SYDNEY CENTRAL CITY PLANNING PANEL

COUNCIL ASSESSMENT REPORT

Panel Reference	2017SWC126
DA Number	DA/888/2017
LGA	City of Parramatta
Proposed Development	28 storey commercial office building with ground floor retail, 4 levels of podium car parking and 2 pedestrian through-site links along southern and western boundaries, respectively. The application is to be determined by the Sydney Central City Planning Panel.
Street Address	32 Smith Street & 93-95 Phillip Street, PARRAMATTA NSW 2150 (Lot 1 DP 541289, Lot 2 DP 566617 and Lot 4 DP 564000)
Applicant	GPT Group Pty Ltd
Owner	GPT Group Pty Ltd
Date of DA lodgement	13 October 2017
Number of Submissions	Nil
Recommendation	Approval subject to conditions
Regional Development Criteria (Schedule 4A of the EP&A Act)	Pursuant to Clause 3 of Schedule 4A of the Environmental Planning and Assessment Act 1979, the development has a capital investment value of more than \$20 million.
List of all relevant s79C(1)(a) matters	<ul style="list-style-type: none"> • Environmental Planning and Assessment Act 1979 • Environmental Planning and Assessment Regulations 2000 • SEPP (Infrastructure) 2007 • SEPP (State and Regional Development) 2011 • SEPP (Syd

Figure 8. Design competition reference control envelope plan (Source: City of Parramatta).

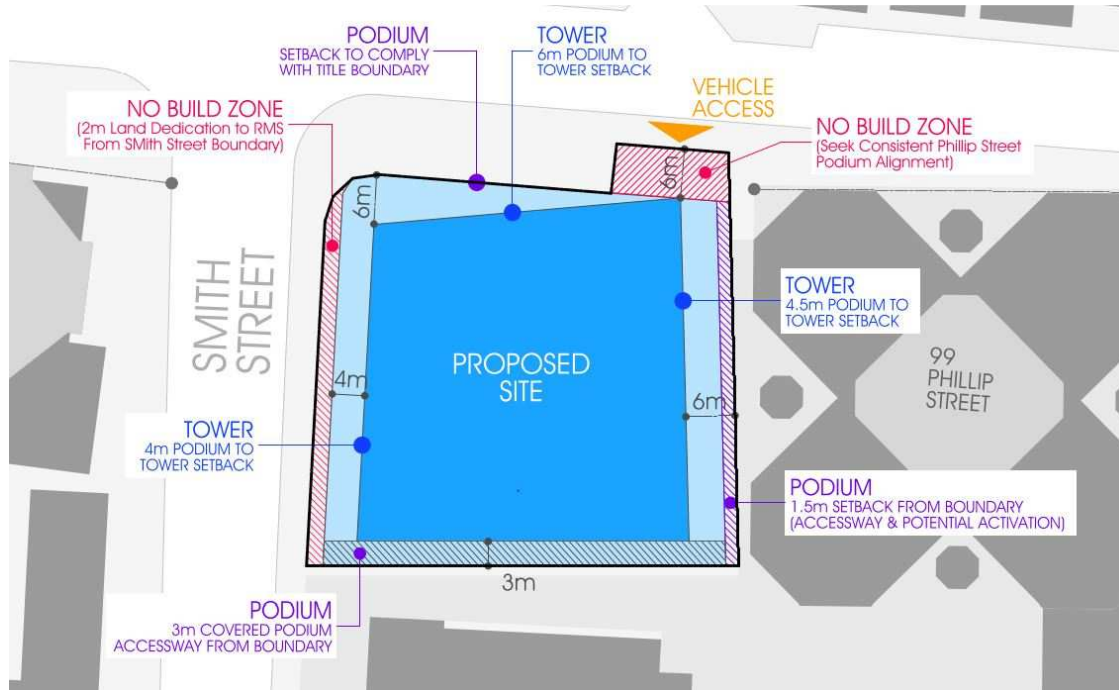
The design competition control envelope prescribed the required setbacks for the proposal, which are demonstrated below in figure 8. The proposal has been designed to incorporate the prescribed setbacks within the design competition brief and not the DCP. Notwithstanding, the proposal does comply with the DCP in certain instances.

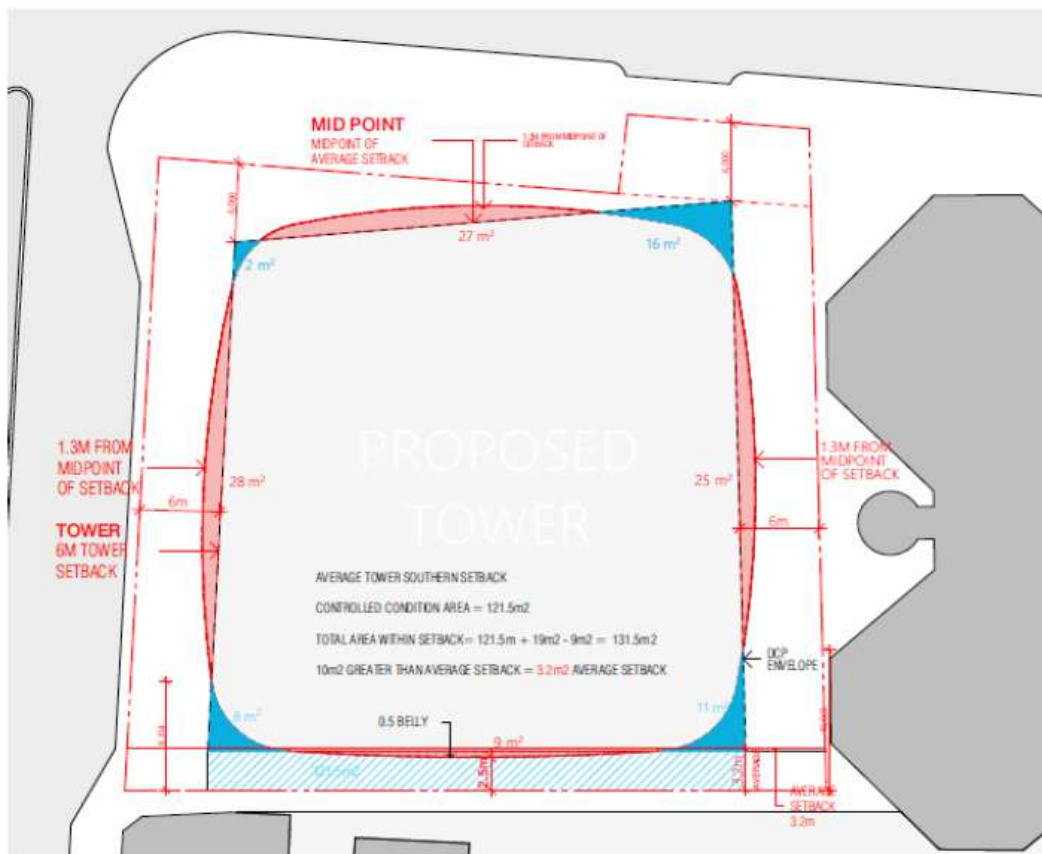
In regards to the Smith Street front setback, the minimum front setback for a small portion of the south western corner is 3.93metres and a 700mm variation is sought. The front setback along Smith Street increases as the building curves towards Phillip Street. The curved elements of the building were a key feature of the winning design excellence scheme and are unique for the Parramatta CBD. The current design including the setback variations were supported upon review by Council's city architect team and the design excellence panel.

In terms of impacts, the variation does not have a negative implication on the public domain, as sufficient space is provided for pedestrian access, bike parking and street tree planting. The setbacks were reviewed by Council's urban design team and no objection was raised in this regard.
